# 325 SEVENTH STREET PROJECT

RESPONSE TO COMMENTS  
FINAL ENVIRONMENTAL IMPACT REPORT

*SCH No. 200712205*

**JUNE, 2011**

Vantage Points, Key

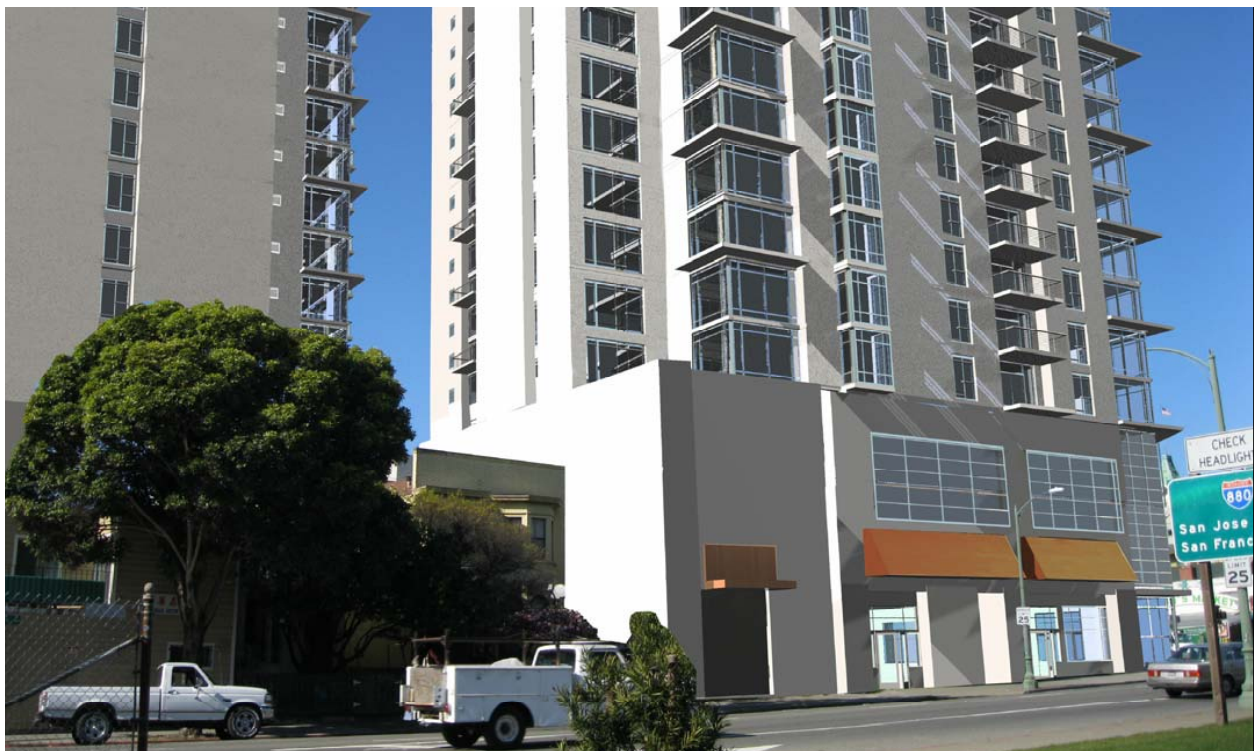
**Response G-2:** In response to this comment and several similar comments by public speakers, additional images have been prepared to better show the proposed Project in context with its surroundings, including the surrounding 7<sup>th</sup> Street / Harrison Square Residential Historic District (see revised **Figures 3-5 through 3-7** in Chapter 4 of this document).

The following changes and new additions are made to the Project Description chapter, Figure 3-5, -6 and -7 starting on page 3-16 to better show the proposed Project in context with its surroundings:

See revised **Figures 3-5 through 3-7** and new **Figure 3-8**

**Figure 3-6**  
**Photo-Simulations of Project**

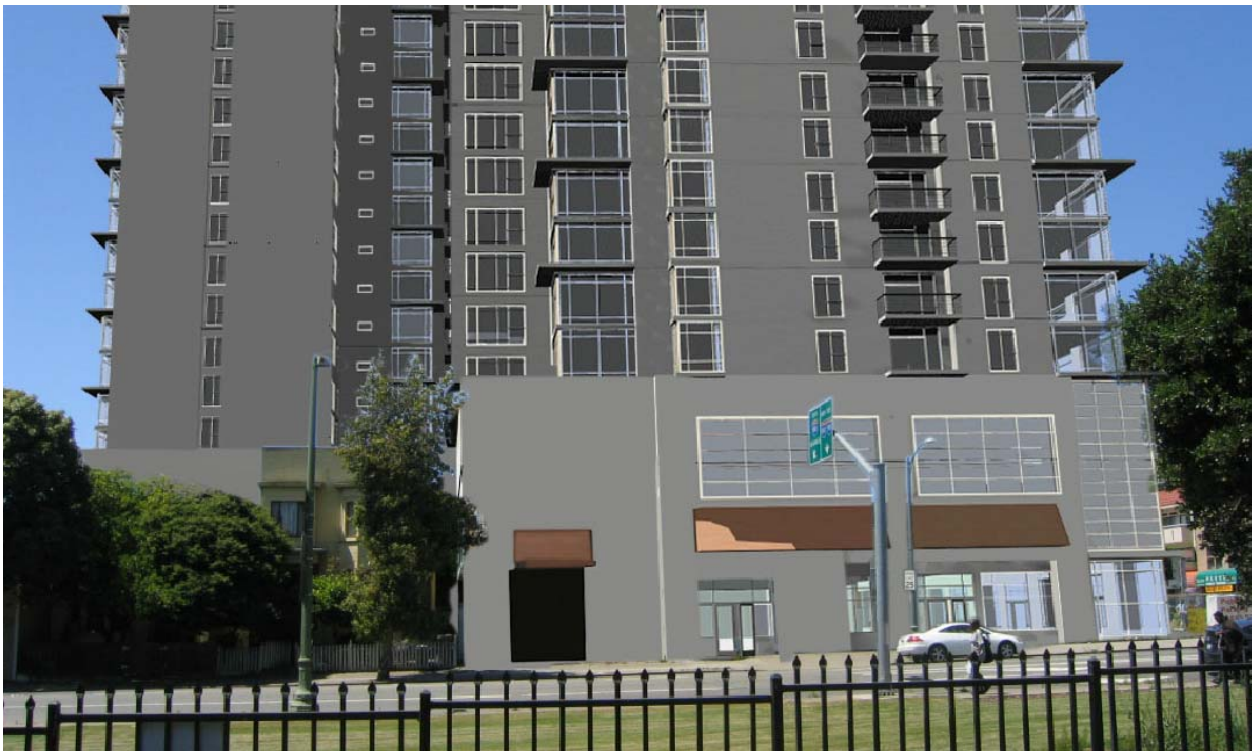
The DEIR is incorrect in its labeling of figures, specifically Figure 3-6. I-9

**Muller-11:** Noted that Figure 3-6 was incorrectly labeled and should show the adjacent structures to remain. Comment noted. The title of this Figure should correctly be labeled "3D Visual Simulation, 6<sup>th</sup> 7<sup>th</sup> and Harrison Street View". This correction is made to the EIR, as also indicated in Chapter 4 of this Response to Comments document. Additionally, images showing the Project in better context with its surroundings have been added to the EIR.

The following change is made to the Project Description chapter to Figure 3-6 on page 3-17:

Figure 3-67: 3D Visual Simulation, 6<sup>th</sup> ~~7<sup>th</sup>~~ and Harrison Street View

**Response I-9:** Comment noted. Figure 3-6 should correctly be labeled "3D Visual Simulation, 6<sup>th</sup> 7<sup>th</sup> and Harrison Street View". This correction is made to the EIR, as also indicated in Chapter 4 of this Response to Comments document.

Figure 4.2-5 Revised  
Project Trip Assignment (Exiting the Project)

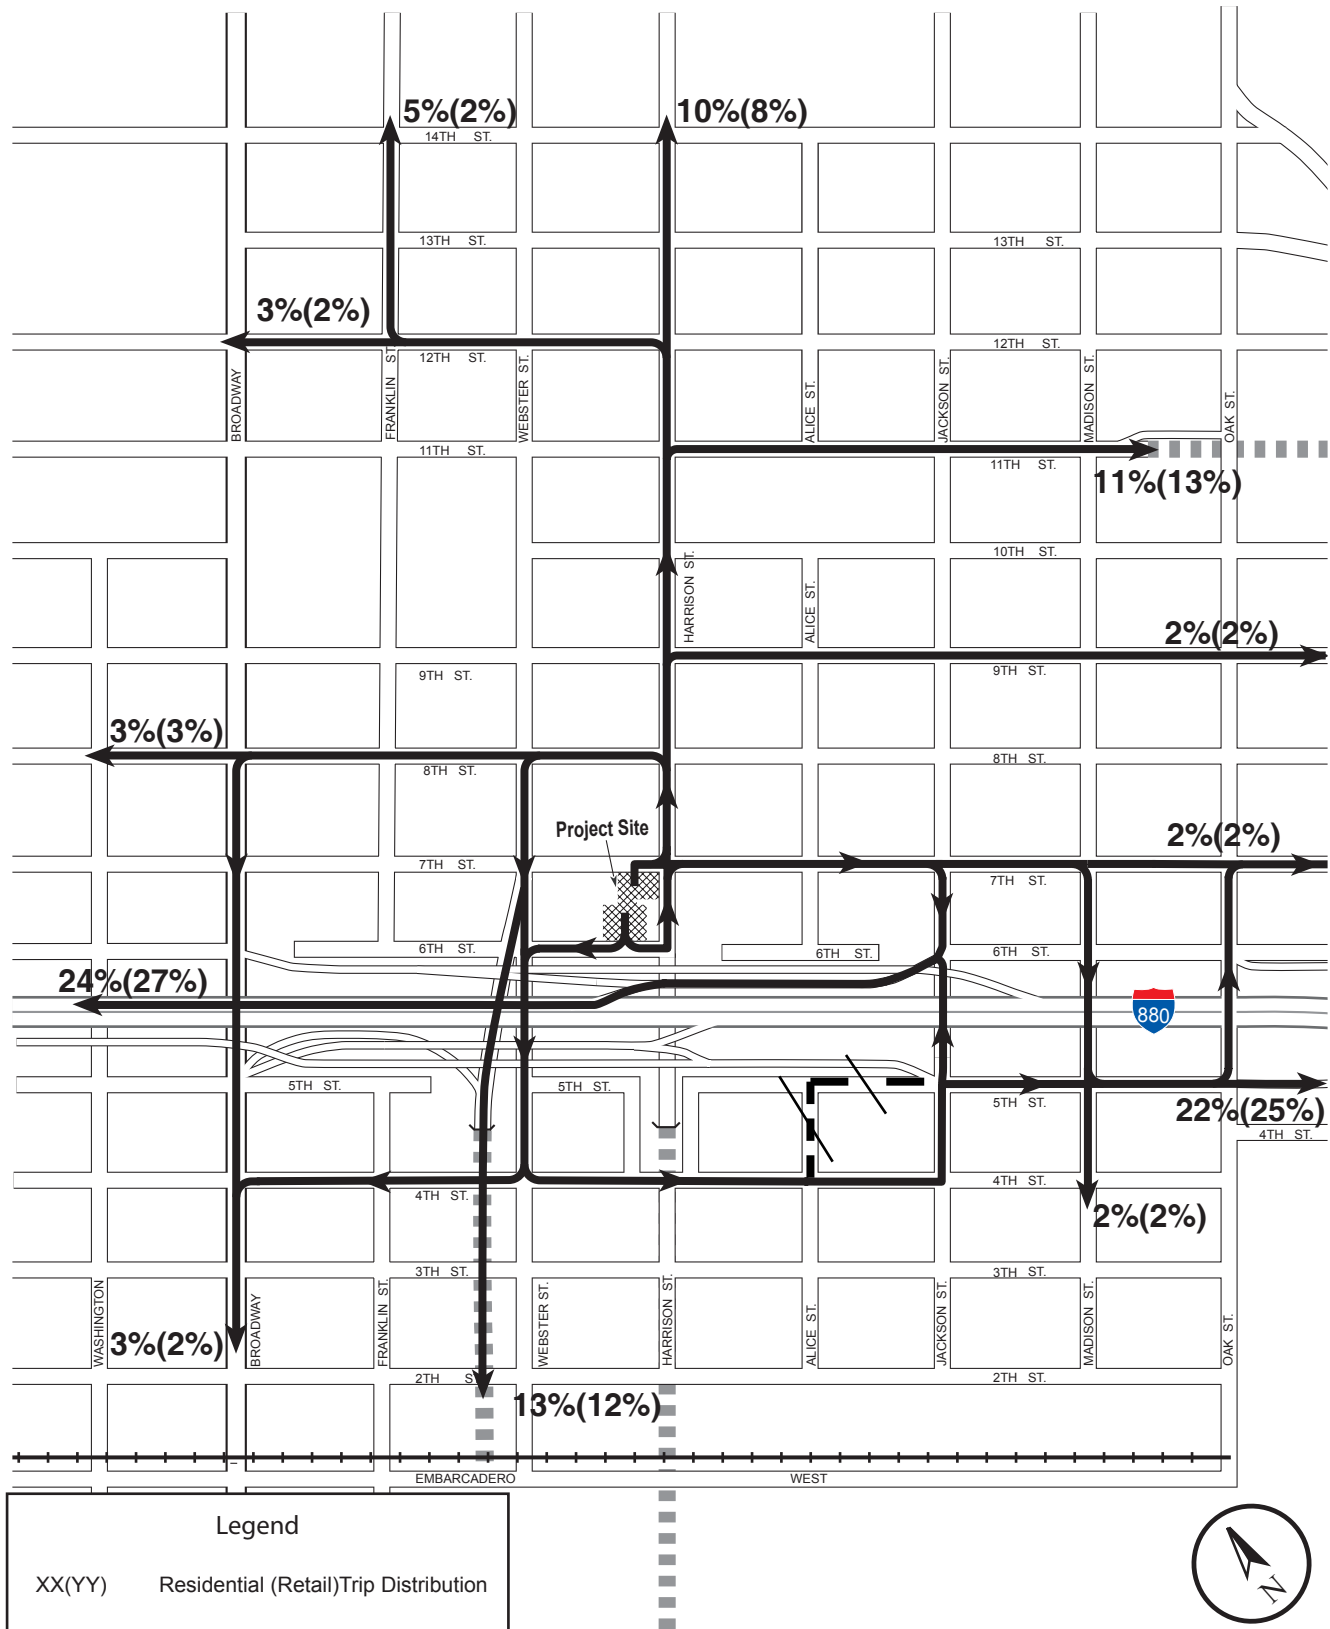
Comment 4: Figure 4.2-5 ("Exiting the Project") assumes that traffic heading east on 4<sup>th</sup> Street will turn left on Alice Street and that traffic heading west will turn left on Broadway. Both assumptions defy common sense. SoNiC believes some traffic heading west on 4<sup>th</sup> Street will turn right on Broadway to access the tube to Alameda while other traffic will turn right and head north on Broadway to a variety of destinations north of the freeway. SoNiC believes very few (if any) vehicles heading east on 4<sup>th</sup> Street will turn left on Alice Street only to merge with the I-980 off-ramp at the very busy 5<sup>th</sup> Street/Jackson Street intersection. Nearly all vehicles heading east on 4<sup>th</sup> Street will turn left on Jackson Street or on Oak Street. Until the traffic consultant acknowledges the existence of Webster Place and unless the Study Area is expanded to include 4<sup>th</sup> Street, it will be impossible to assess the impact of the proposed Project on the Jack London District or to suggest appropriate mitigation measures where needed.

**Response H-5:** This comment suggests that Figure 4.2-5 of the Draft EIR (“Exiting plus Project Traffic”) incorrectly assumes that traffic heading east on 4<sup>th</sup> Street will turn left on Alice Street, and that traffic heading west will turn left on Broadway. The comment suggests that some traffic heading west on 4<sup>th</sup> Street will instead turn right on Broadway to access the Tube to Alameda, while other westbound traffic on 4<sup>th</sup> Street will turn right and head north on Broadway to a variety of destinations north of the freeway, and that few (if any) vehicles heading east on 4<sup>th</sup> Street will turn left on Alice Street (which merges with the 1-980 off-ramp at the very busy 5<sup>th</sup> Street/Jackson Street intersection) but instead nearly all vehicles heading east on 4<sup>th</sup> Street will instead turn left on Jackson Street or on Oak Street.

In response to this comment, the traffic patterns of Project-generated traffic, as shown on Figure 4.2-5 of the DEIR, has been revised to indicate that a certain amount of Project-generated traffic exiting from the Project would head east on 4<sup>th</sup> Street, would make a turn left on Jackson Street, and then turn right on 5<sup>th</sup> Street to get on I-880 southbound. As a result, traffic conditions for the 5<sup>th</sup>/Jackson Streets intersection were also revised as indicated below. Changes to Figure 4.2-5, Figure 4.2-6, Figure 4.2-7, Figure 4.2-8 and Figure 4.2-9 are also made to the EIR, as indicated in Chapter 4 of this Response to Comments document.

Figure 4.2-6 Revised  
Project Trips AM (PM) Peak Hour

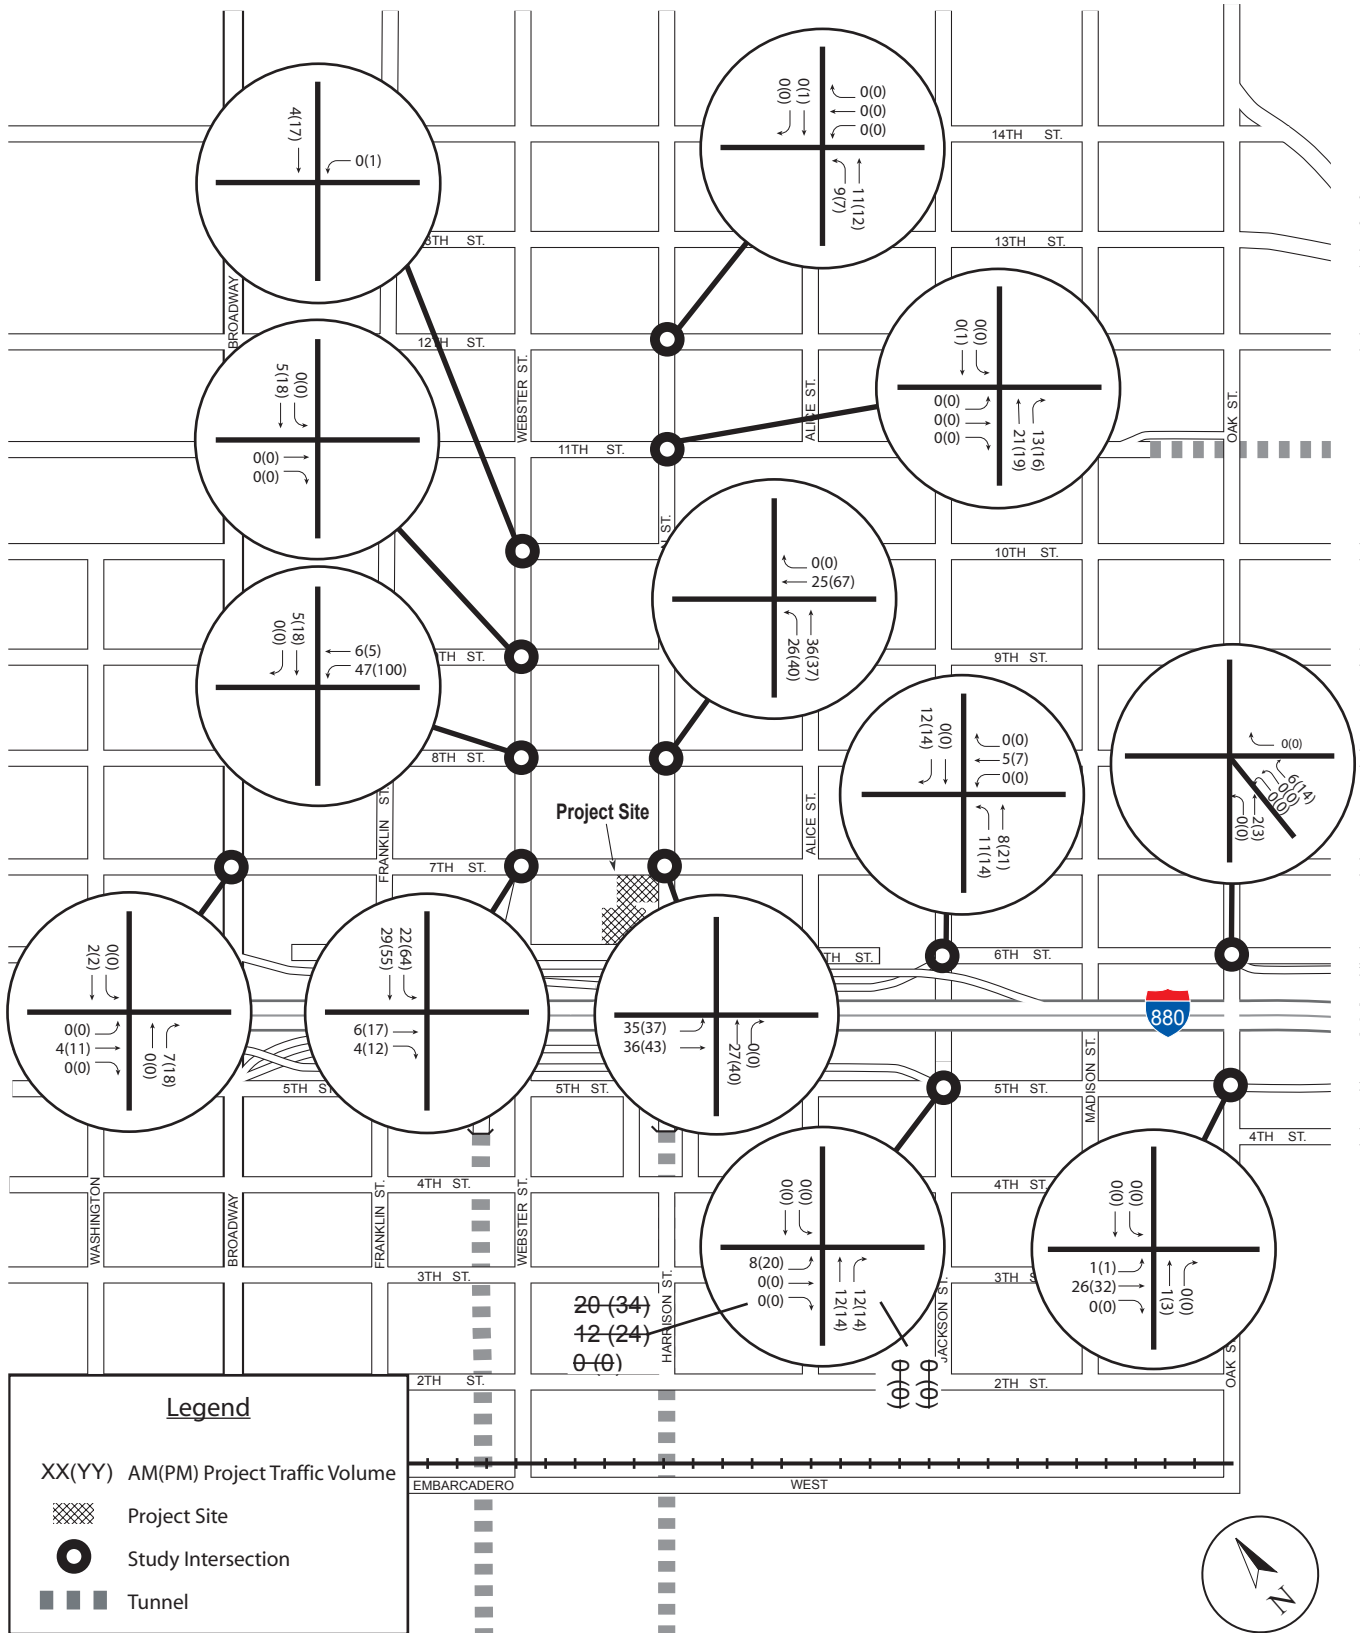
The number of project trips at the Fifth and Oak Streets intersection indicated on page 4.2-29, Figure 4.2-6 is incorrect. The project trips should be calculated by multiplying the 262 net increase PM trips (Table 4.2-9) with the project trip assignment of 25 percent (Figure 4.2-5). Therefore, the intersection should have 66 PM peak trips as opposed to the 32 stated in the DEIR. Please explain this inconsistency.

The numbers in the Draft EIR are correct. Of the total 262 net PM peak hour trips, approximately 131 trips (49 residential and 82 retail trips) would be outbound trips. As shown in Figure 4.2-5, which represents outbound assignment only, the outbound trip distribution for the eastbound direction at the intersection of 5<sup>th</sup>/Oak Street would be 22% for retail trips and 25% for residential trips. Therefore, the PM Peak hour Project trips at the intersection of 5<sup>th</sup>/Oak Street would be 32 PM peak hour Project trips (11 residential and 21 retail trips).
